DEPARTMENT OF THE ARMY  
DETROIT DISTRICT, CORPS OF ENGINEERS  
BOX 1027  
DETROIT, MICHIGAN 48231

SUBJECT: NRC Midland Project, Request for Additional Borings and Existing  
Soil Data

DISCUSSION OF THE APPLICANT'S POSITION  
ON THE NEED FOR ADDITIONAL BORINGS  
FOR  
MIDLAND PLANT UNITS 1 AND 2  
CONSUMERS POWER COMPANY  
DOCKET NUMBERS 50-329 AND 50-330

Figure 1  
(See Reference 1)

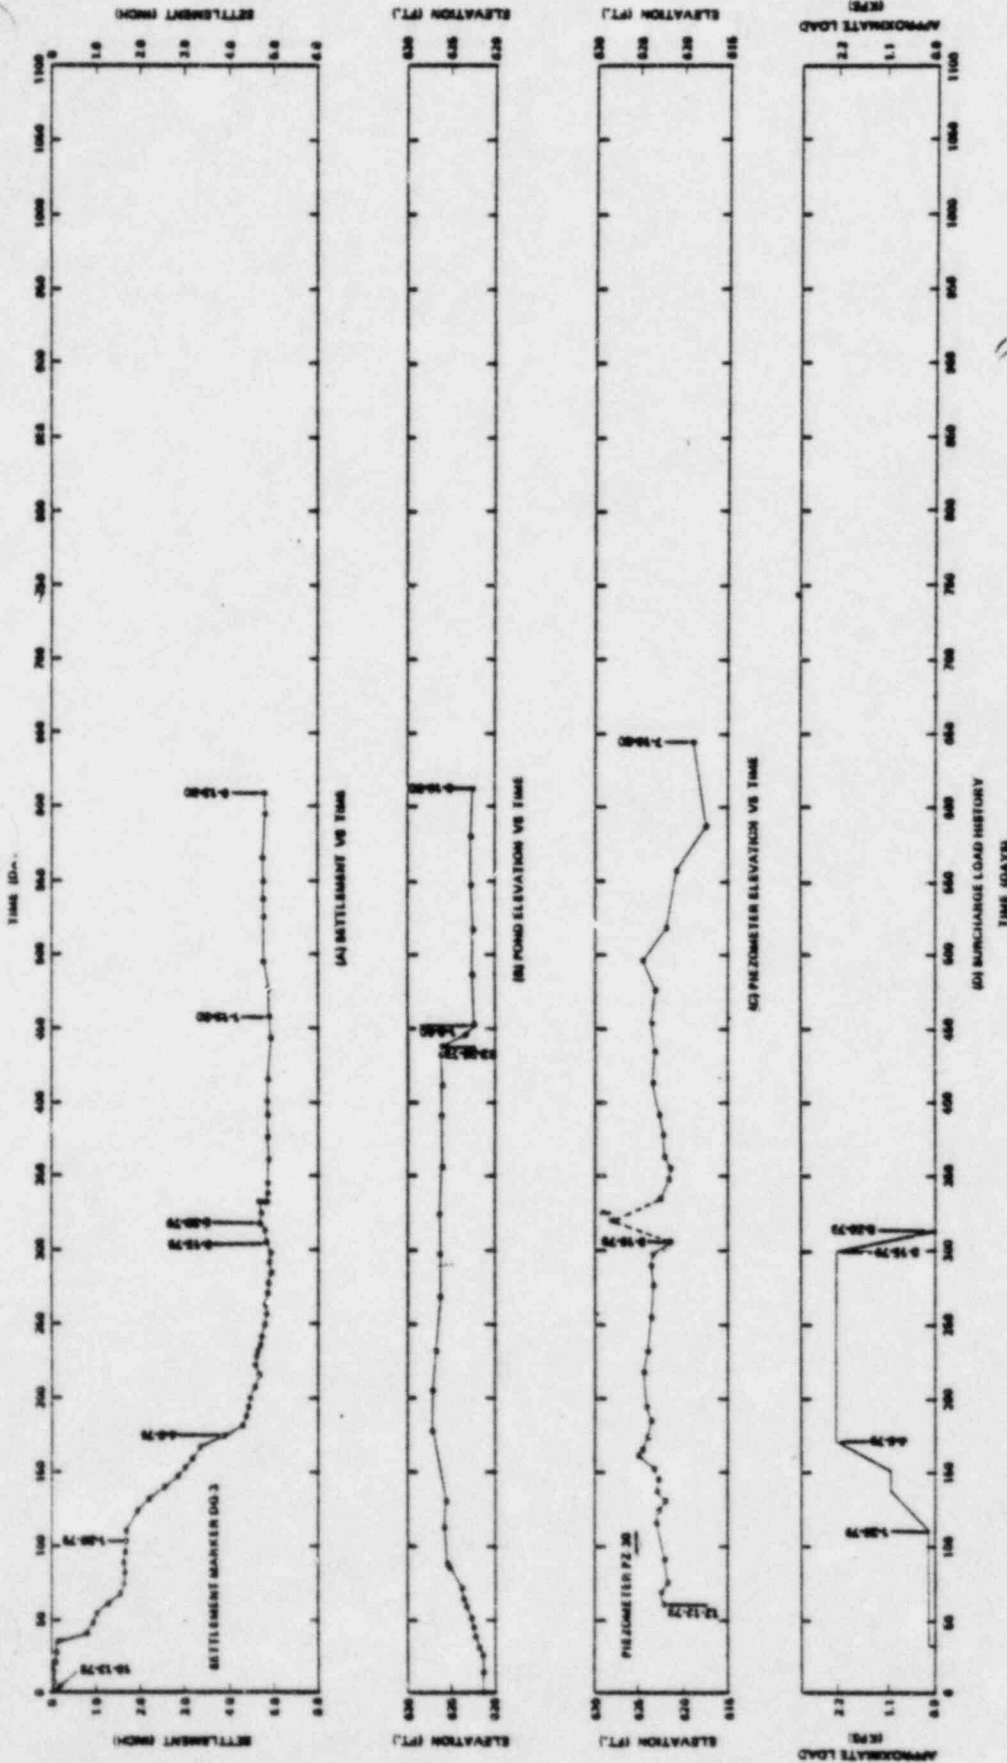
The surcharge was applied in three increments to a maximum height of 20 feet (approximately 2.2 ksf). The stresses prevailing during surcharging at all depths in the fill beneath the building exceeded those that will prevail while the structure is operational including those applied by future site dewatering.<sup>(2,3)</sup> Figure 1 shows the surcharge history and Figure 2 shows the stress distribution below the building during and after the surcharge. The cooling pond water level was raised to the maximum design level before surcharge reached its maximum level.<sup>(3)</sup> The groundwater table below the diesel building rose to approximately elevation 625, which is 3 feet below the base of the foundations as shown on Figures 27-5 through 27-49 in the response to NRC Question 27, Revision 6. The primary reason for requiring the pond level to be raised while the surcharge was being applied was to reduce capillary action and increase saturation levels closer to the planned groundwater elevation of 627. Pond water level was maintained at the maximum level throughout the period of surcharging. As can be seen from Figure 1, settlement occurred rapidly as the load was applied. When the surcharge reached its maximum level, the rate of settlement decreased rapidly. As anticipated, excess pore water pressures developed when the load was applied and dissipated rapidly, indicating rapid consolidation of the fill.<sup>(4)</sup>

Figure 3  
 (See Reference 1)

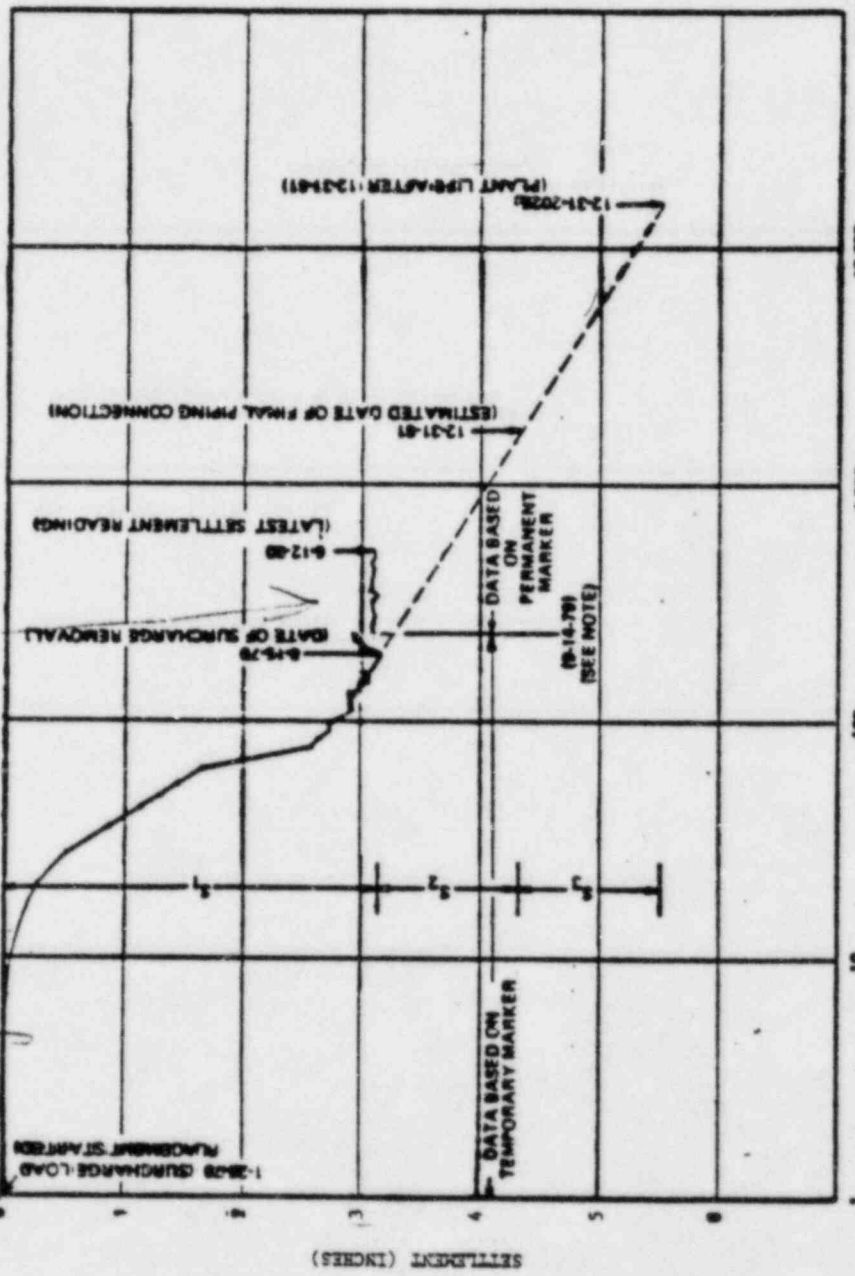
Primary settlement occurred rapidly and settlement measurements indicated secondary consolidation was occurring as verified by the straight line on the semi-log plot shown on Figure 3. This figure is typical of all the settlement curves shown in Figures 27-6 and 27-51 through 27-78 which exhibit a straight line settlement

Figure 4  
(See Reference 1)

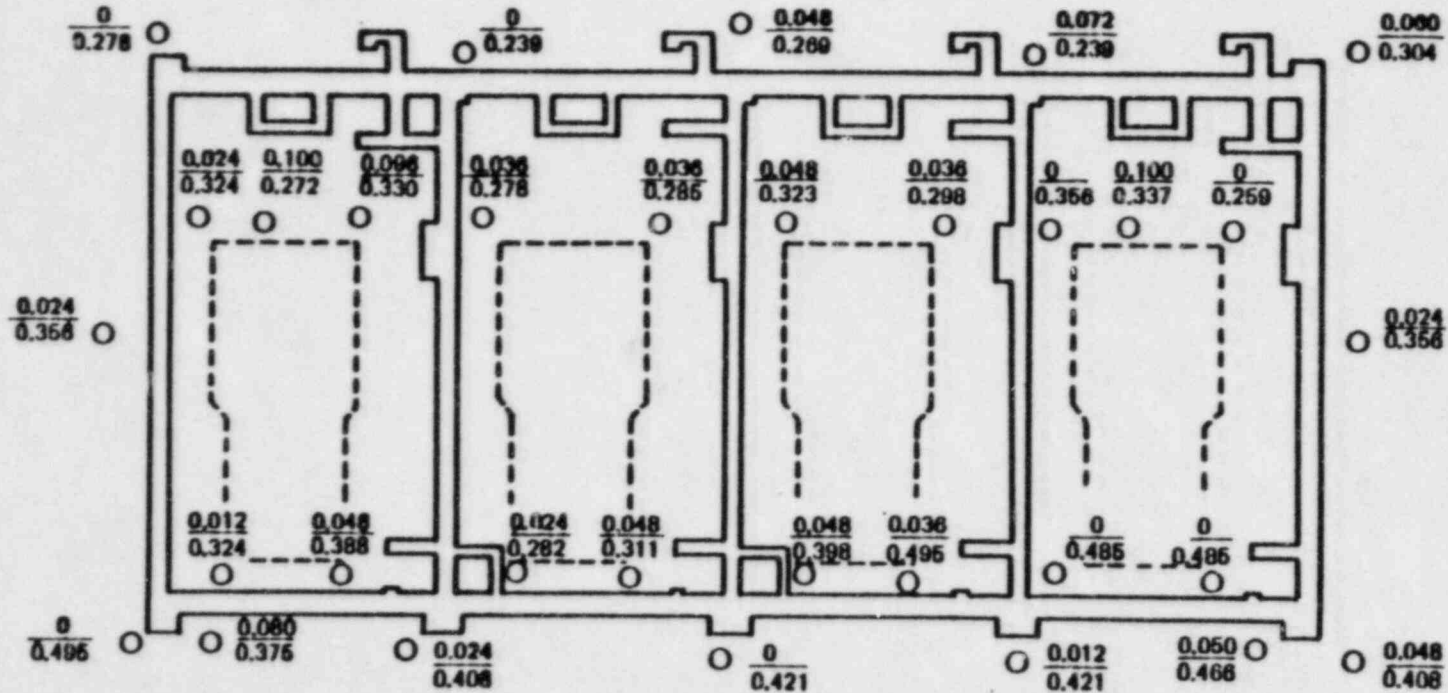
during secondary consolidation. This behavior has been recorded on many projects including the Chicago Auditorium where this straight line secondary behavior has been observed for 60 years. Settlement trends based on rates experienced while the surcharge was in place were extrapolated to predict maximum settlements expected to occur over the life of the plant. This prediction is based on the conservative assumption that surcharge loading conditions remain for the life of the structure. Settlement measurements made during the period between September 14, 1979, and June 12, 1980, show that, on the average, the building experienced less than 0.1 inch of settlement as shown on Figure 4.<sup>(4,7,8)</sup>
